PRODUCT / PROCESS CHANGE NOTIFICATION

1.1 Company	 STMicroelectronics International N.V
1.2 PCN No.	MDG/23/14099
1.3 Title of PCN	Implementation of a PBO (Polybenzoxazole) protective layer over product passivation for STM8A (AUTOMOTIVE) listed products
1.4 Product Category	STM8A
1.5 Issue date	2023-06-22

PCN14099 : Implementation of a PBO (Polybenzoxazole) protective layer over product passivation for STM8A (AUTOMOTIVE) listed products

PBO implementation context and reliability plan

Passivation Damage Eradication Plan

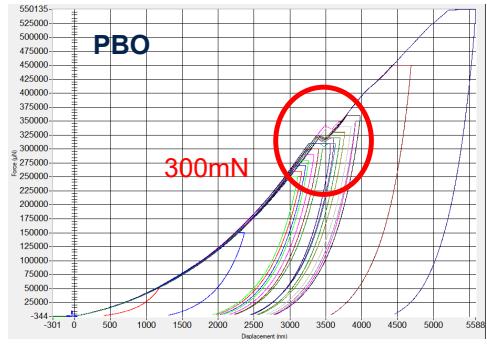
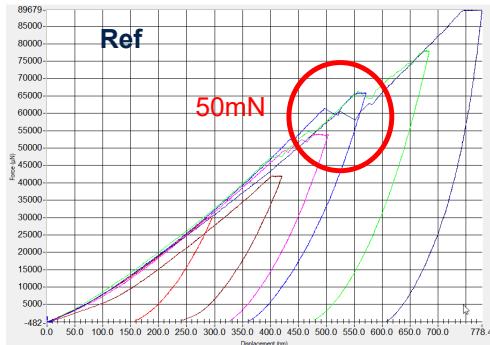
The continuous improvement plan for eradication of passivation damage applied in these years on 8bit MCUs was focusing of 3 key areas of the manufacturing flow:

- Wafer transportation
- Automatic Visual Inspection (AVI)
- Removal of manual wafer handling steps during assembly

The various identified and implemented improvement actions were able to **significantly reduce** the ppm level of this failure mode **but not to eradicate** it.

A **breakthrough** to further reduce the baseline defectiveness level, and to protect versus possible quality excursions, **must** therefore go through an **intrinsic product robustness** improvement action: the implementation of a polyimide protection layer (**PBO**) over product passivation.
